# **Review of the Queensland Rail (QR) West Moreton System**

**for the Queensland Competition Authority**

**May 2014**

**B&H Strategic Services Pty Ltd**

**Figure 1 Cost per km for MGT**

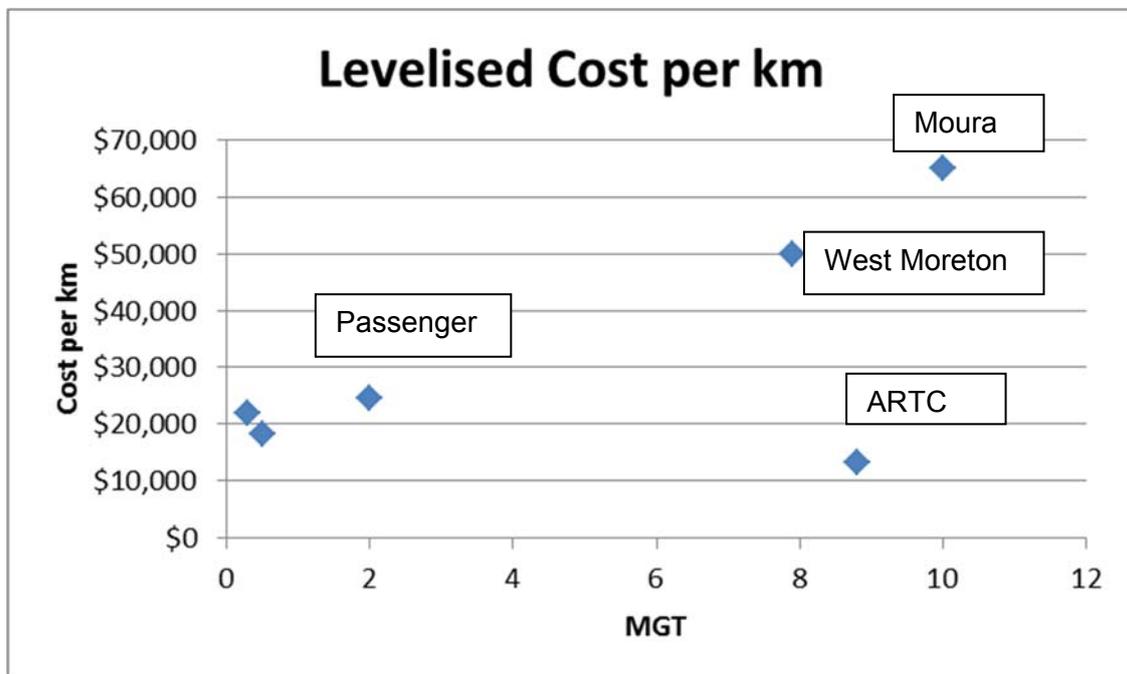
These results are shown graphically in Figure 1 and Figure 2 and show that with the exception of the outlier ARTC there is consistency in the trend of maintenance costs in levelised<sup>60</sup> maintenance cost. ARTC's costs as reported have not included large scale capital upgrading costs performed at the time but nevertheless have shown a consistent trend over the past decade to be Australia's best performer in these measures.

We conclude that if it not were for the rebuilding tasks being performed as represented by the maintenance budget, the maintenance costs would be comparable to other well documented benchmarks.

Figure 2 Costs per km for MGTkm

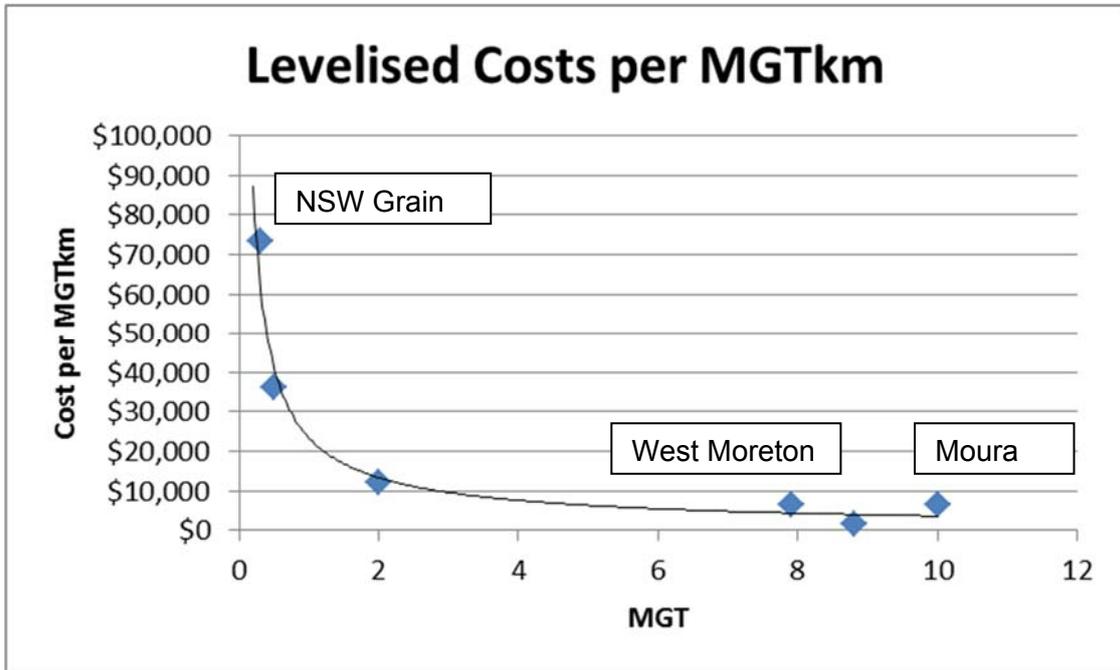
In Figure 2 the costs per MGT km for Million Gross Tonne Kilometres (MGTkm) is shown and indicates the same consistency. It is unsurprising that cost per MGTkm increases rapidly for low tonnage lines. The West Moreton system lies to the right of the knee in the curve indicating that when the reinforcement of the line stops it is likely to be within the more stable region of the trend provided the tonnages remain and the maintenance tasks are not reactive as they are now.

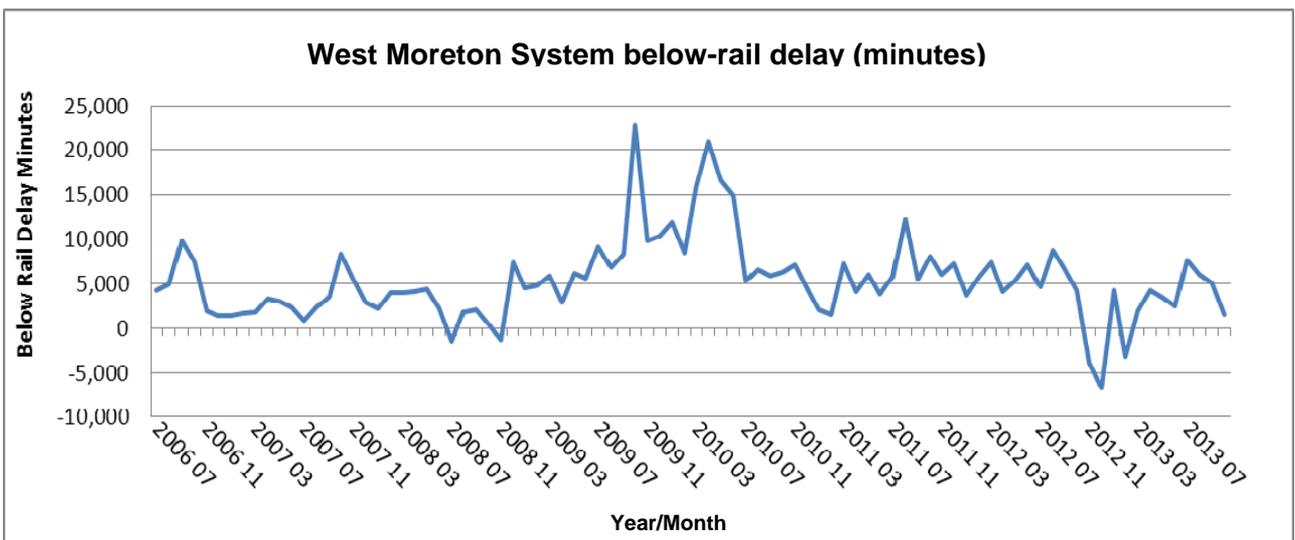
c) *What was the estimated improvement in the reliability of track through a reduction in track under speed restriction and below rail delays (from and to kms under speed restriction and from and to below rail delays)? What increase in capacity did those improvements create?*

The measurement of speed restriction percentage (%) on the West Moreton System is shown in the image below. It is important to note that track under speed restriction can be caused by a number of factors external to Queensland Rail particularly variations in climate (such as changes in temperature) and rainfall. The improvement or reduction in speed restrictions over the timeframe cannot be linked solely to the WSAR project.
